SUBJECT: ARKANSAS NUCLEAR ONE, UNITS 1 AND 2 – FLOOD HAZARD MITIGATION STRATEGIES ASSESSMENT (CAC NOS. MF7894 AND MF7895; EPID L-2016-JLD-0007)

STAFF ASSESSMENT RELATED TO THE
MITIGATION STRATEGIES FOR
ARKANSAS NUCLEAR ONE, UNITS 1 AND 2
AS A RESULT OF THE REEVALUATED FLOODING HAZARDS REPORT
NEAR-TERM TASK FORCE RECOMMENDATION 2.1- FLOODING
CAC NOS. MF7894 AND MF7895

Figure 3.2-1 FLEX Equipment Deployment Routes and Staging Location (adapted from Figure A-1 of Entergy's May 31, 2017, submittal (ADAMS Accession No. ML17153A295))

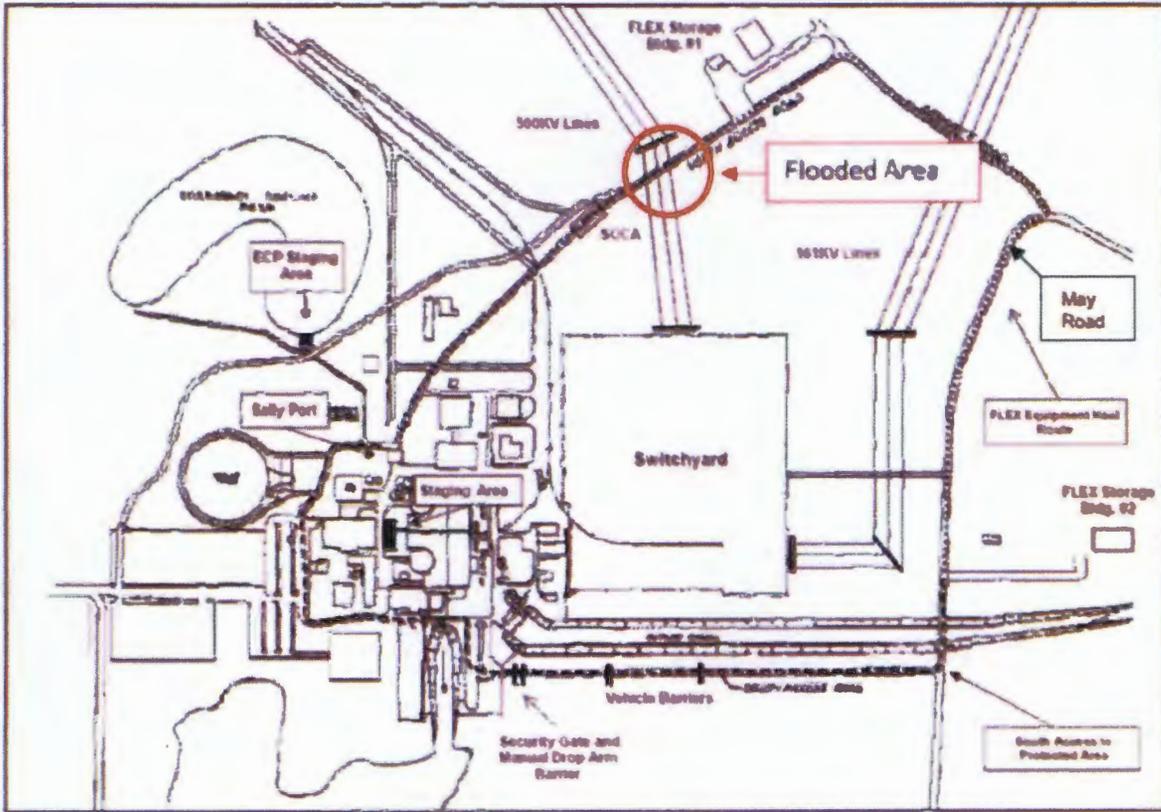
The staff notes that based on the FHRR, the flooding around the staging area (see Figure 3.2-1) is minimal and below the ground clearance of the FLEX equipment. The licensee also included a commitment in its MSA to either establish trigger-point entry conditions and appropriate procedural changes to prestage the FLEX equipment or to modify the road such that the deployment path is not affected by the LIP. Since warning time is available prior to the onset of the LIP, the NRC staff finds it reasonable that the modified FLEX strategy (i.e., prestaging of FLEX equipment) can be implemented as intended. Alternatively, the staff notes that modifications to the FLEX strategy would not be needed if the licensee changes the North Access Road elevation such that deployment of the FLEX equipment is not impacted by the LIP event.
